Addendum No. 01

Date: September 17, 2025

Project: MSU Barnard 111 – Lithography Lab

SHEET
M200

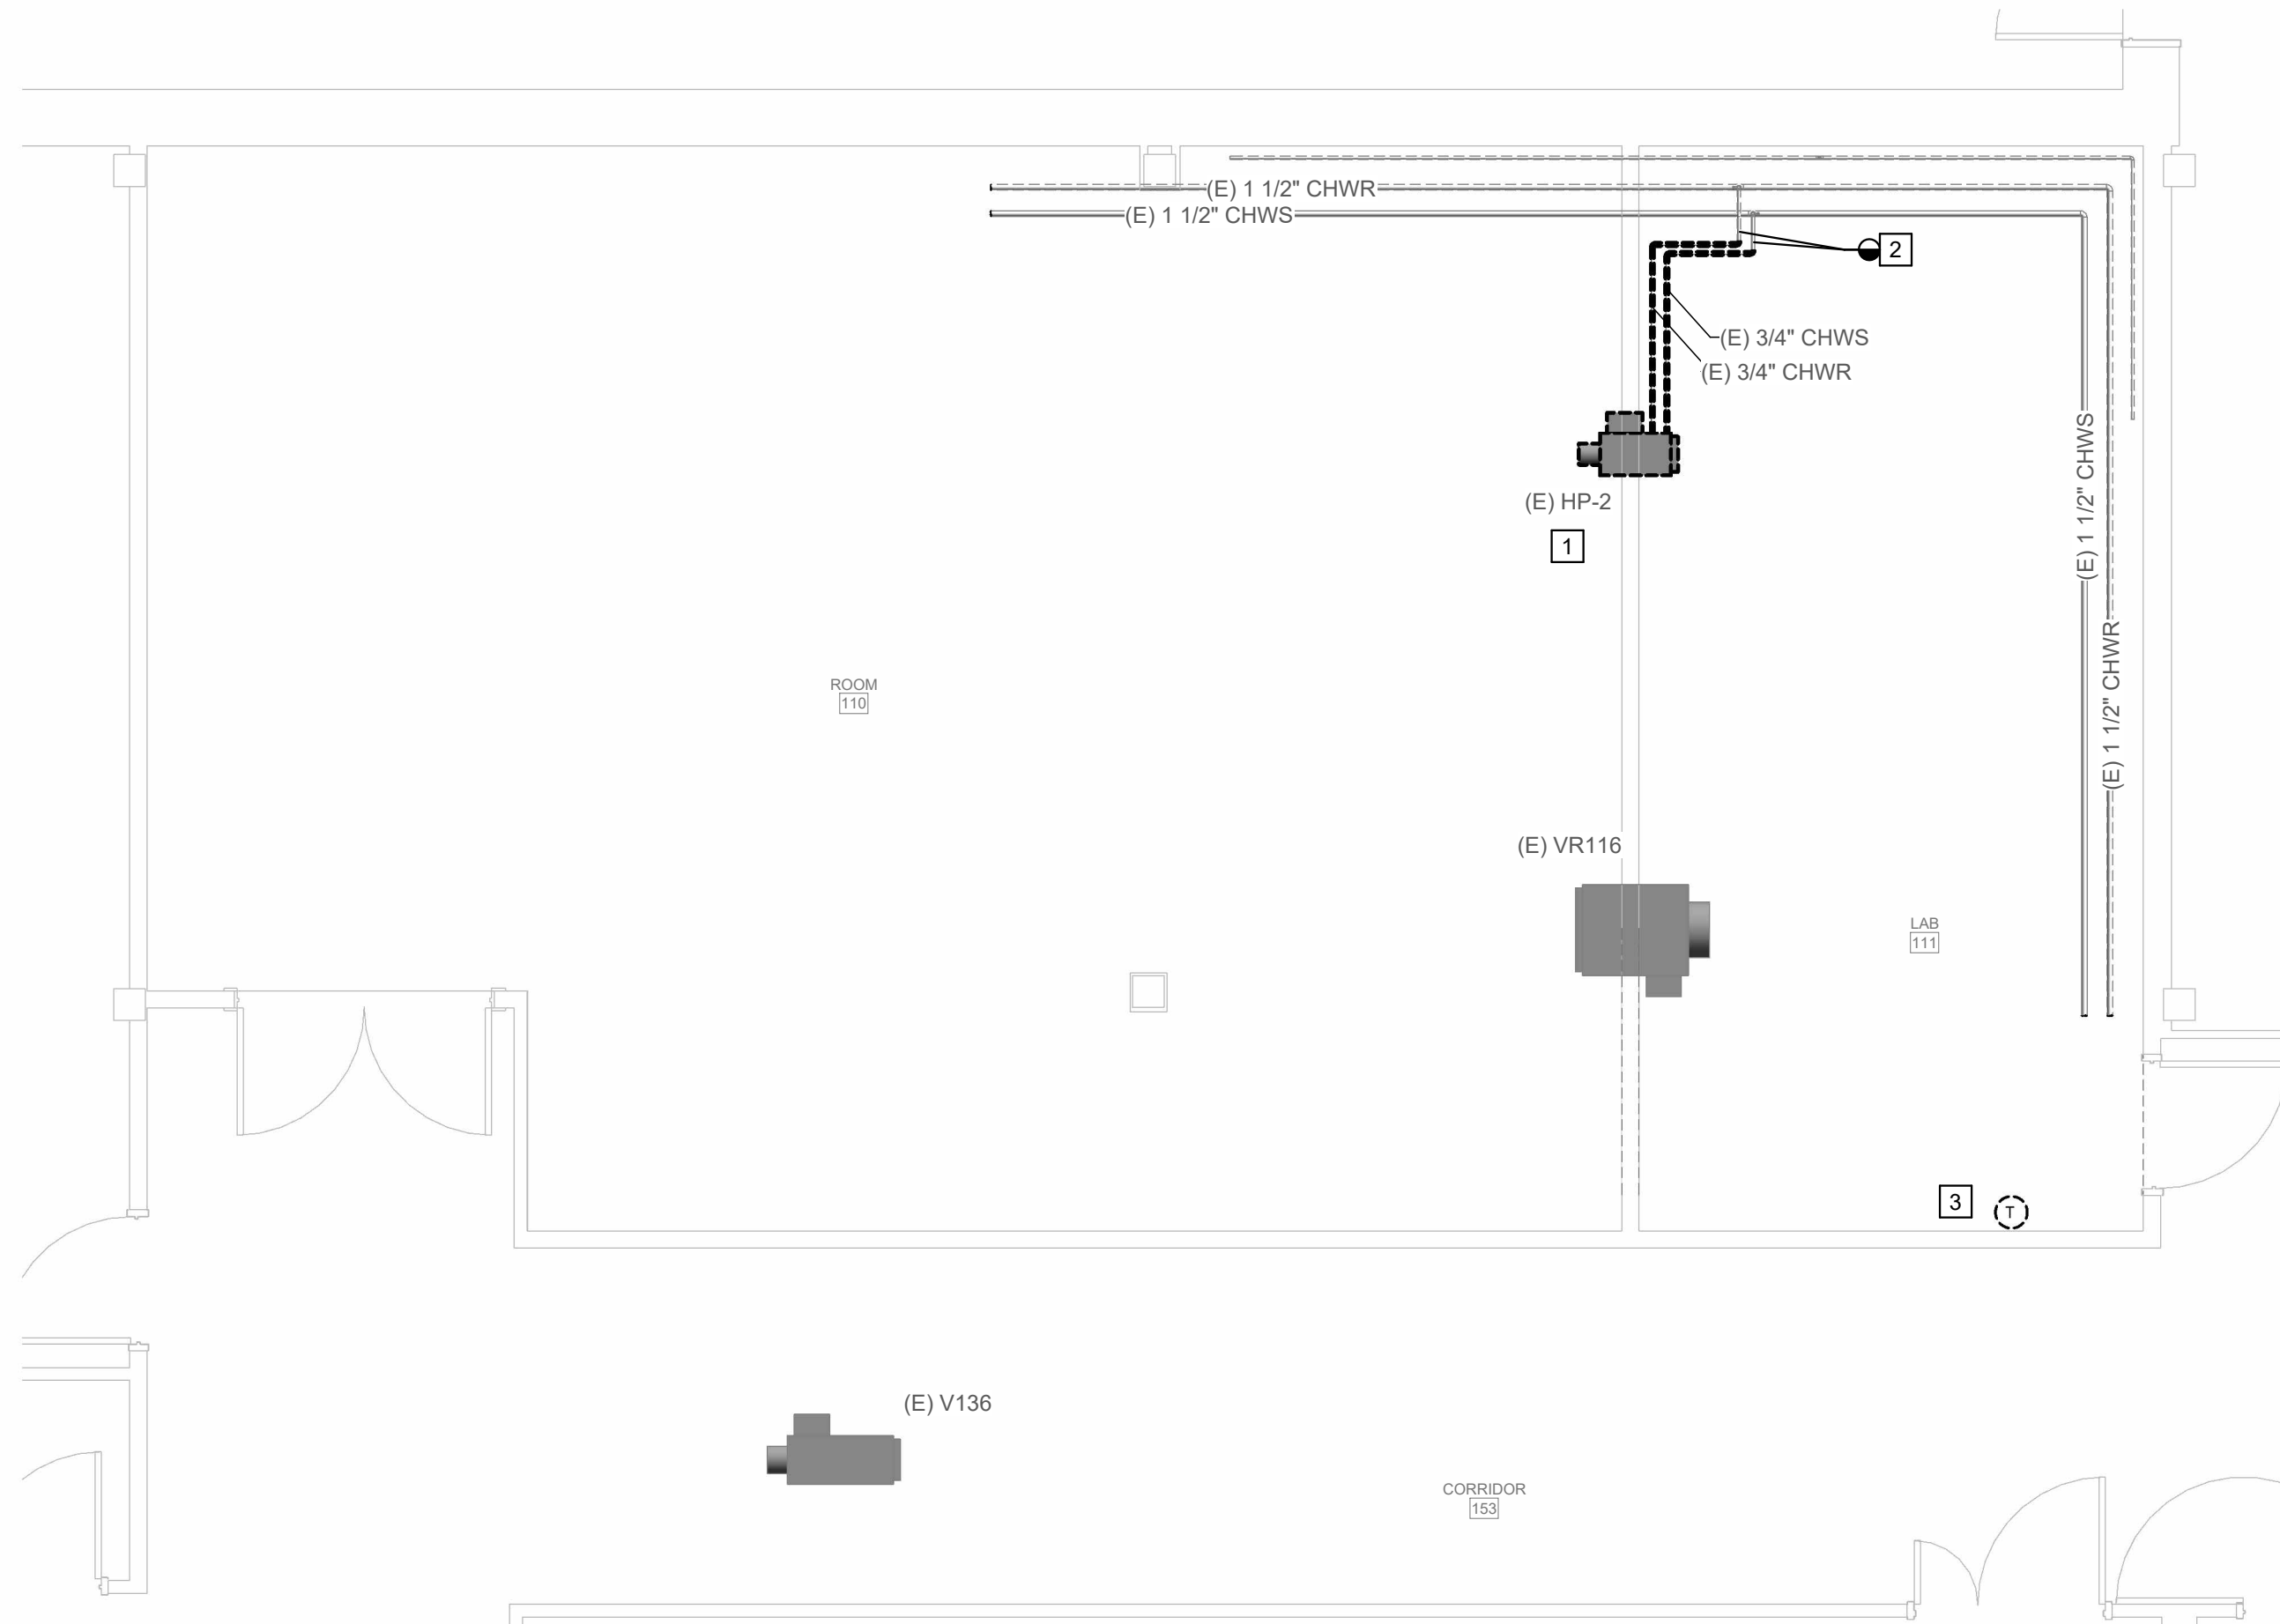
SHEET M200

1. ADD: Keynote note #15.

14. HUMIDITY CONTROLLER PROVIDED WITH HUMIDIFIER. INSTALL AT 44" AFF. ROUGH IN BY EC. INSTALLED BY MC. THIS WORK IS TIED TO ALTERNATE #2
15. RELOCATE EXISTING SPRINKLERS IN ROOM 111 AS REQUIRED TO MAINTAIN THE MAXIMUM SPACING TO SIDEWALLS OF 7'-6" MAXIMUM AND SPACING BETWEEN SPRINKLERS OF 15'-0" MAXIMUM TO COMPLY WITH NFPA 13 AND THE UL LISTING OF THE EXISTING SPRINKLERS. RELOCATION SHALL UTILIZE SCHEDULE 40 STEEL PIPE WITH THREADED JOINTS AND MALLEABLE IRON THREADED FITTINGS. PERFORM ALL WORK IN ACCORDANCE WITH NFPA 13. COORDINATE SPRINKLER SYSTEM IMPAIRMENT WITH THE OWNER AND FOLLOW THE REQUIREMENTS OF NFPA 25 CHAPTER 15. ALL WORK SHALL BE COMPLETED DURING WEEKEND HOURS WHEN BUILDING OCCUPANT USAGE IS REDUCED AND SHALL BE COMPLETED WITHIN SIX HOURS. NOTIFY MSU DEPARTMENT OF PUBLIC SAFETY AND BOZEMAN FIRE DEPARTMENT AT START OF THE IMPAIRMENT AND WHEN THE WORK HAS BEEN COMPLETED AND THE SYSTEM IS RESTORED TO OPERATION. CONTRACTOR SHALL ENGAGE A LICENSED FIRE PROTECTION CONTRACTOR TO PERFORM WORK.

2 FIRST FLOOR REMODEL SPECIAL SYSTEMS PLAN
E400 1/4" = 1'-0"

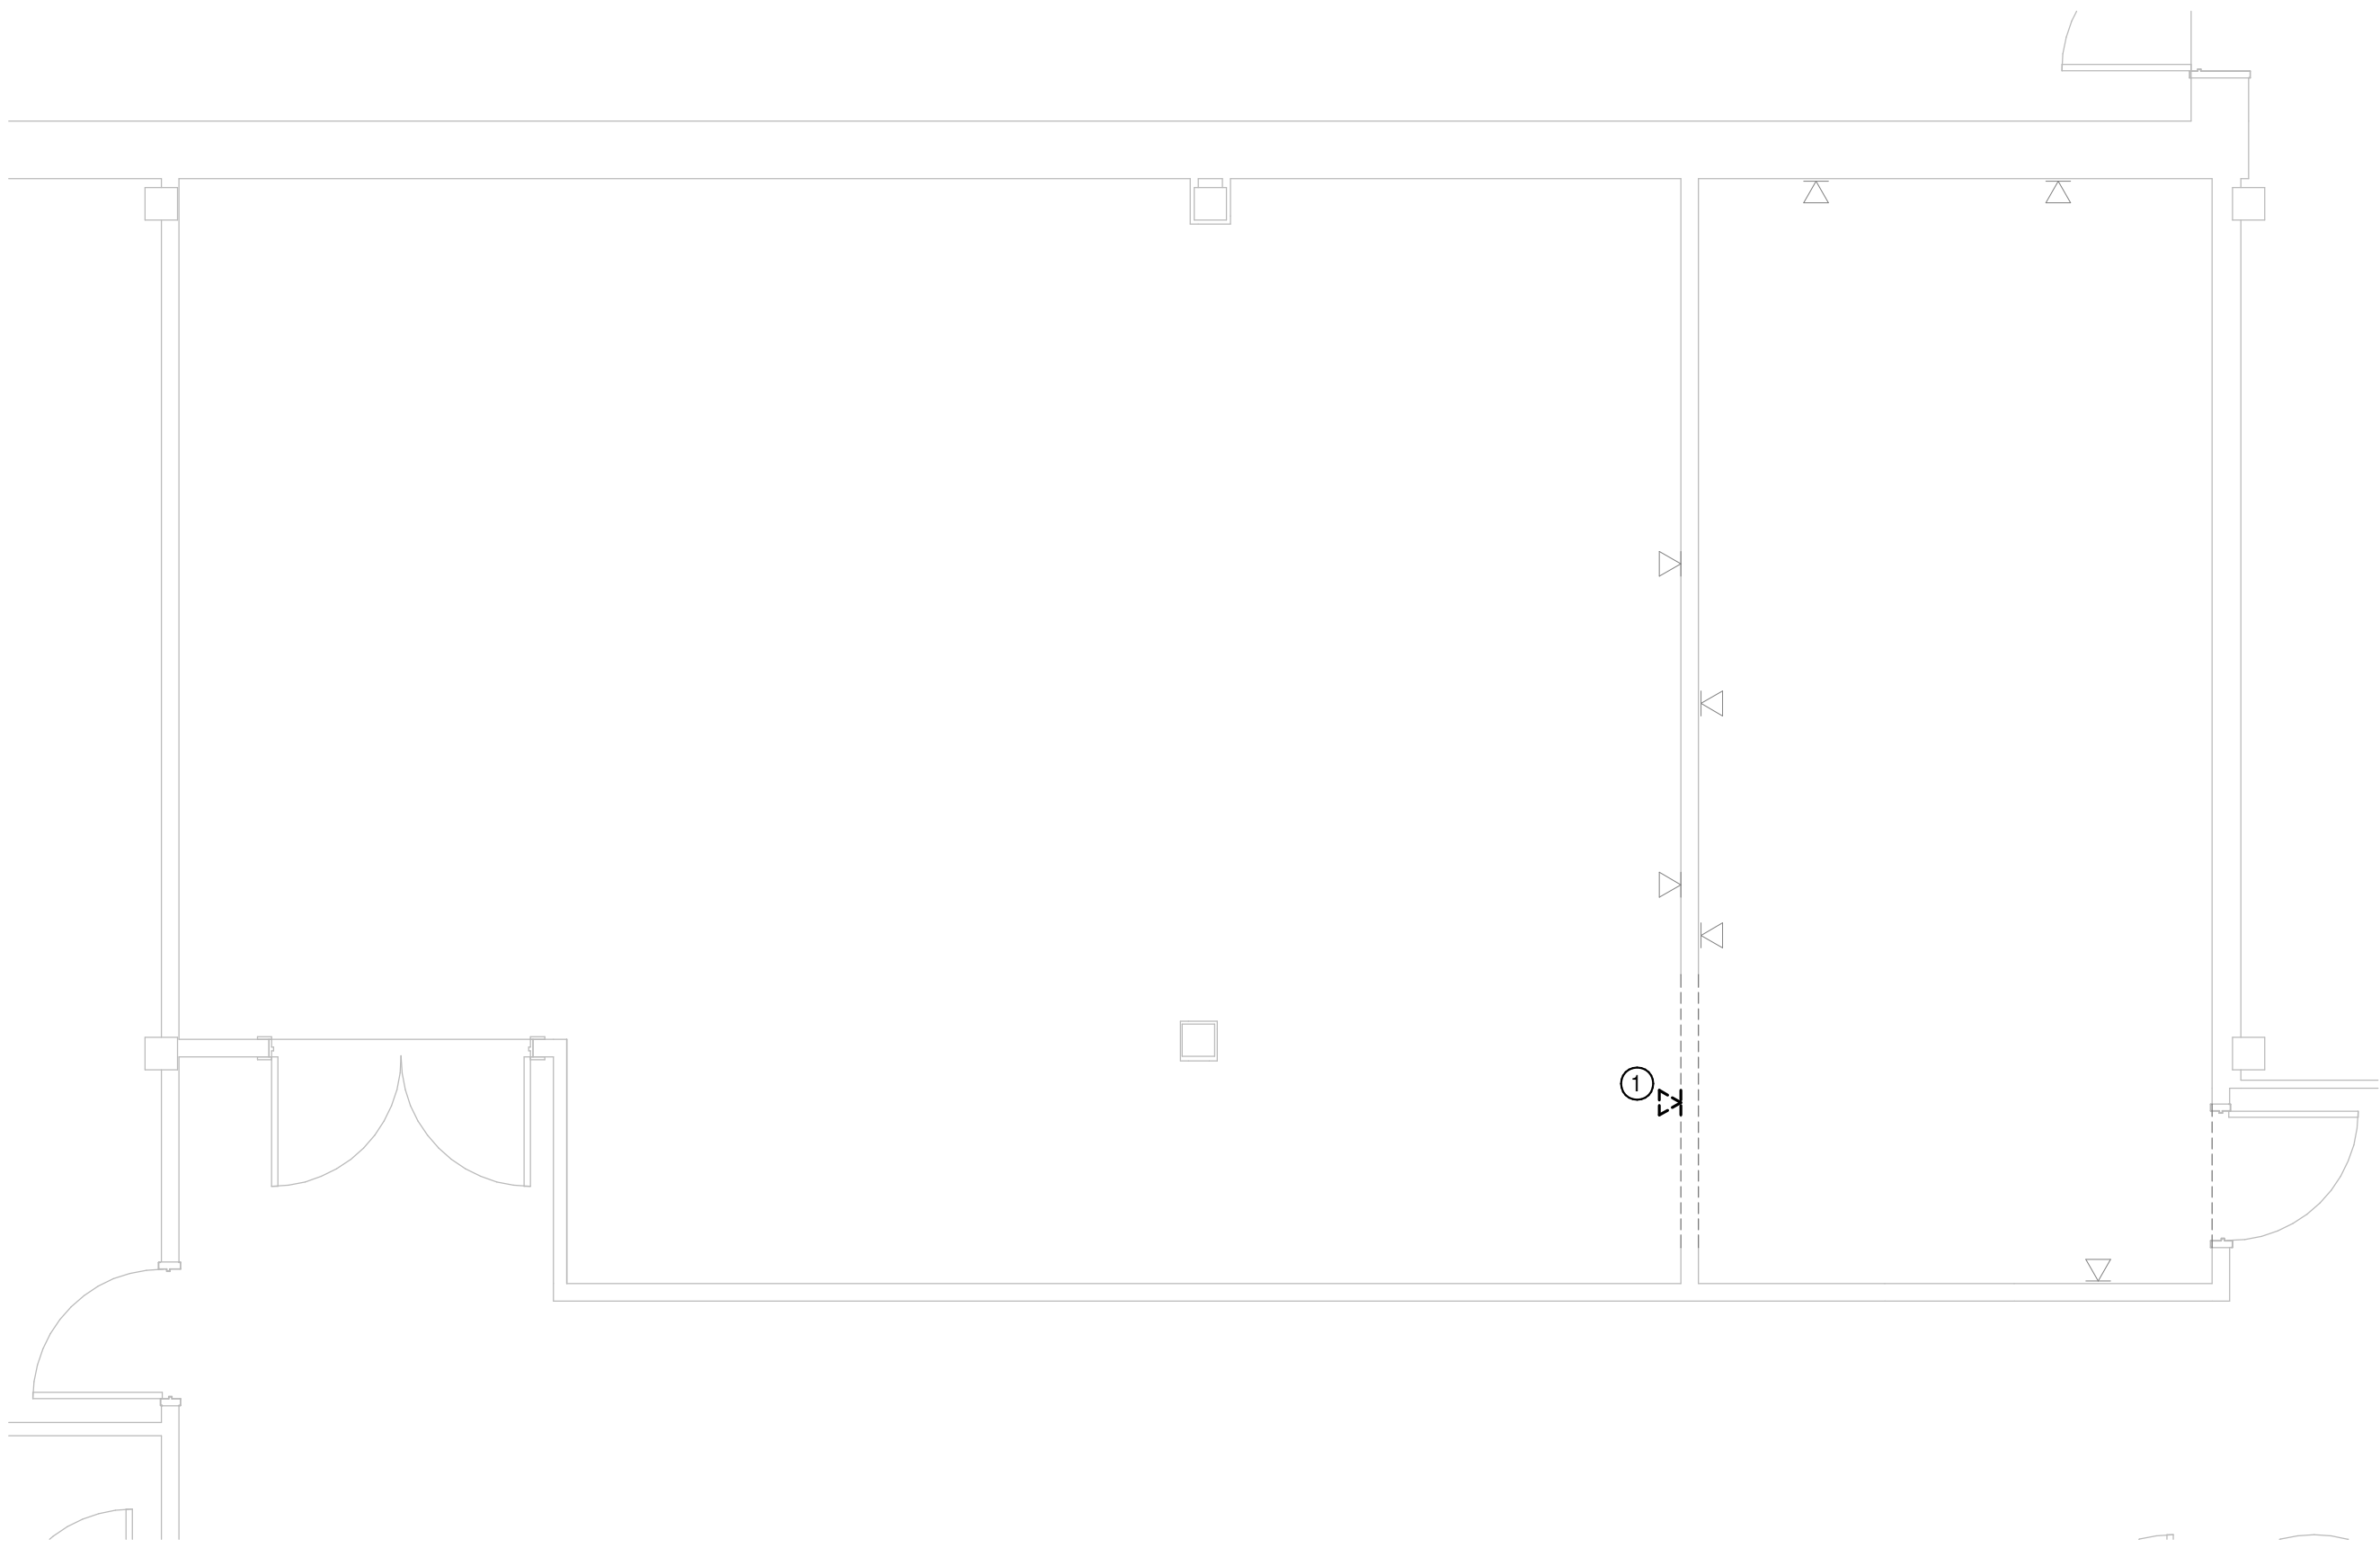
SHEET E400

1. ADD: Keynote '3' to First Floor Remodel Special Systems Plan and keynote legend.

- CONTRACTOR SHALL USE EXISTING CATEGORY 6 CABLING RETAINED FROM DEMOLITION AND RE-ROUTE TO EXTENT POSSIBLE. ALL REUSED CABLING SHALL PASS CABLE TESTING. PROVIDE NEW CABLING BACK TO EXISTING DATA ROOM IF ANY CABLING FAILS TEST.
- PHONE LINE AND LAN CONNECTION FOR NEW LITHOGRAPHY MACHINE. COORDINATE EXACT LOCATION OF DATA OUTLET WITH EQUIPMENT INSTALLER BEFORE ROUGH IN.
- PROVIDE NEW HORN STROBE AND CONNECT TO NEAREST NAC CIRCUIT. CONTRACTOR SHALL VERIFY CIRCUIT LOAD TO ENSURE AMPERAGE MEETS CODE REQUIREMENTS. SEE PLAN FOR FACP LOCATION.
